**PLANNED UNIT DEVELOPMENT
STAFF REPORT****Date: February 18, 2016****DEVELOPMENT NAME**

Pinebrook Investment, LLC

CONTEMPLATED USE

Planned Unit Development Approval to amend a
previously approved Planned Unit Development to allow
changes in parking layout, location of marque signs,
sidewalk designs and expansion of westernmost driveway
to accommodate an additional turning lane.

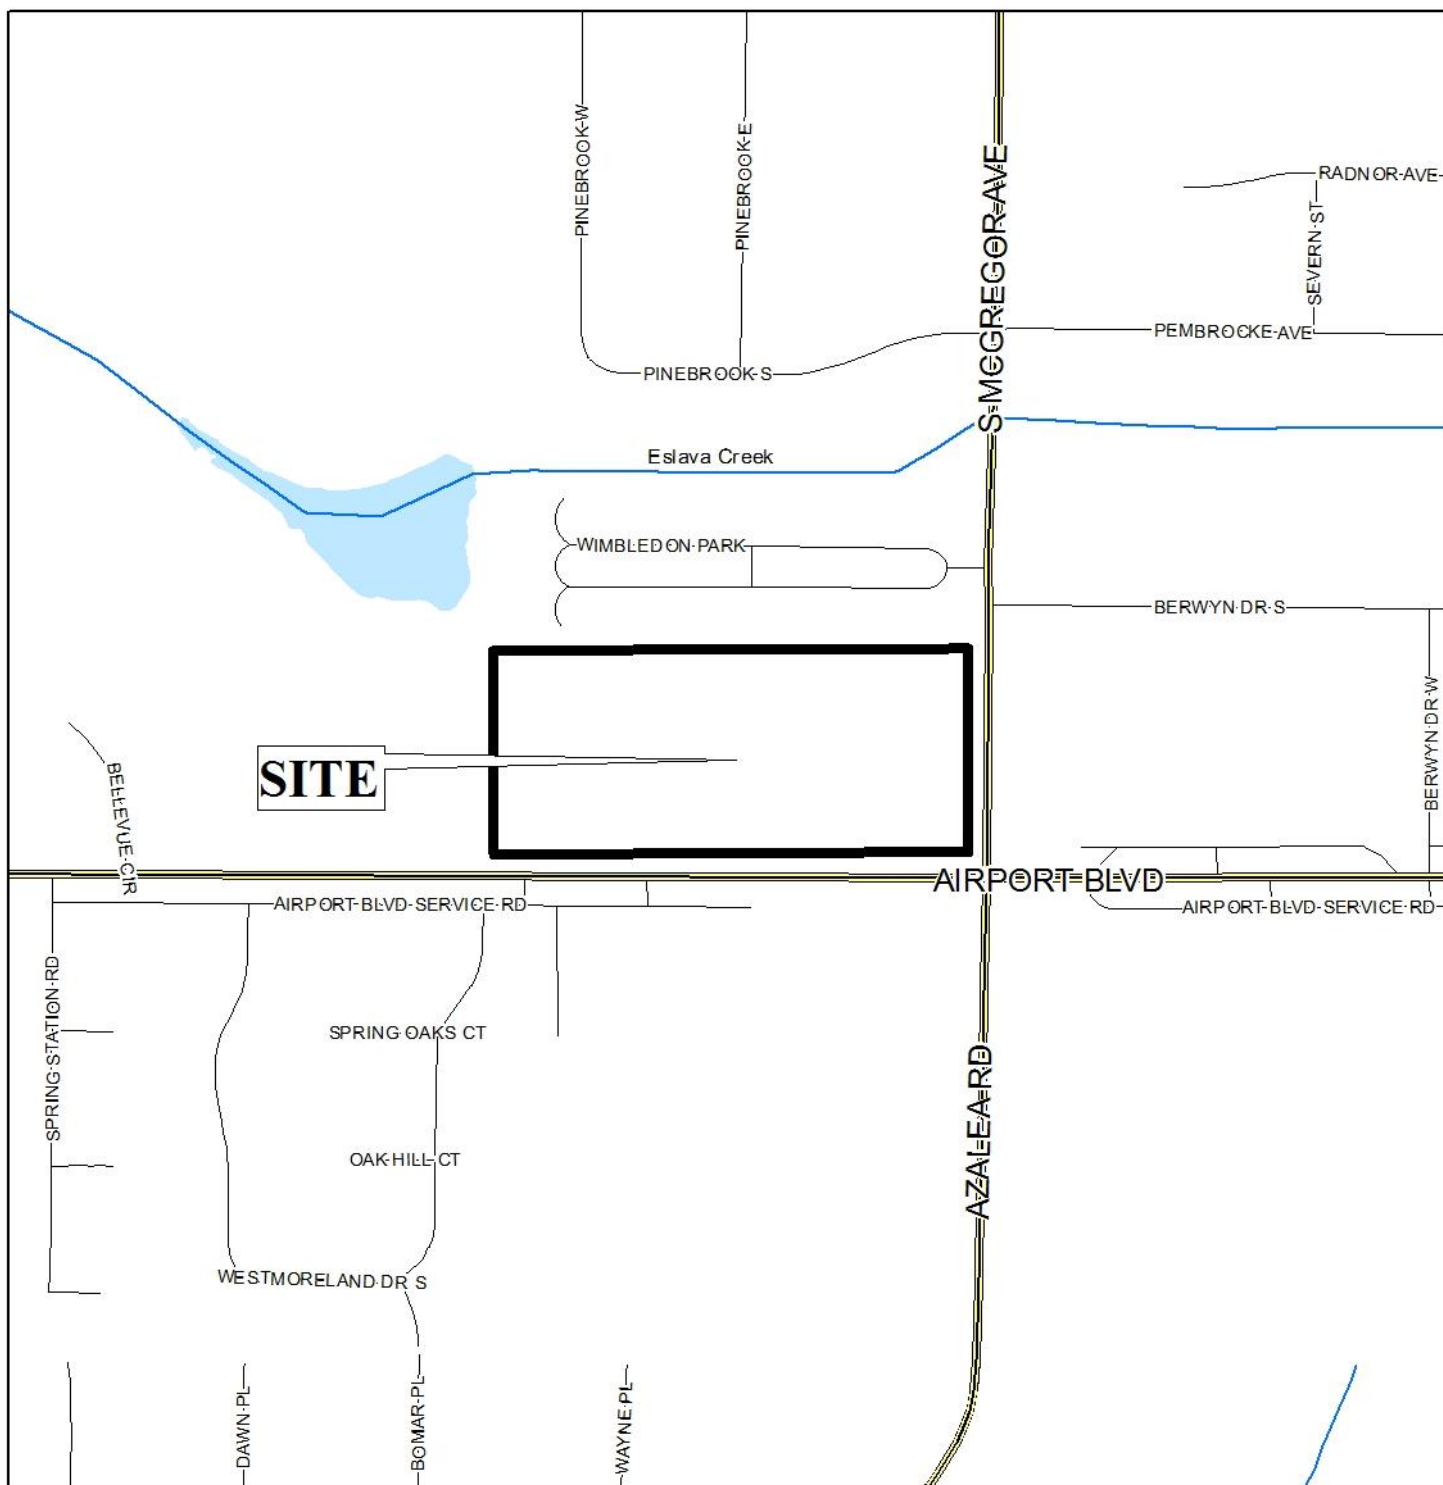
A revised site plan was received by staff, and it appears that the primary revision is to the parking on the East side of the shopping center, along McGregor Avenue. A revised tree and landscape plan was not submitted.

The revised site plan now depicts two rows of angled parking on the East side, facing in opposite directions, with a 17 to 20.5 foot wide two-way drive aisle: Section 64-6.A.2. of the Zoning Ordinance requires that two-way drive aisles be a minimum of 24 feet in width.

No information was provided with the revision regarding if a sidewalk would be provided on the West end of the development along Airport Boulevard, as originally required, or if a Sidewalk Waiver request would be submitted to remove this last remaining unbuilt but required segment of sidewalk.

- 2) Revision of the site plan to depict a 24-foot wide parking drive aisle if two-way access is proposed on the East side of the center, along McGregor Avenue, and rearrangement of parking spaces to comply with minimum size requirements found in Section 64-6. of the Zoning Ordinance.;

- 3) Revision of the site plan to comply with Traffic Engineering comments: “*Driveway number, size, location and design are subject to the approved PUD for this site, and shall be approved by Traffic Engineering and conform to AASHTO standards. Any required on-site parking, including ADA handicap spaces, shall meet the minimum standards as defined in Section 64-6 of the City’s Zoning Ordinance. There are several parking spaces on the west side of the site that restrict the access aisle to 14’ – 15’, and a staircase on the north side of the site (Petsmart) that restrict the access aisle to 17’. These widths are not conducive to two-way traffic and should be improved to provide a minimum 20’ access aisle. The angled parking spaces proposed on the east side of the site do not meet the city’s standard for required access aisle width, as defined in Section 64-6. Aisles 24’ wide are required for two-way traffic (17’ – 20.5’ is not recommended).*”;

- 4) Revision of the site plan to depict a sidewalk between the signalized intersection and the Western-most boundary of the site, or provision of a statement that a Sidewalk Waiver will be requested; and
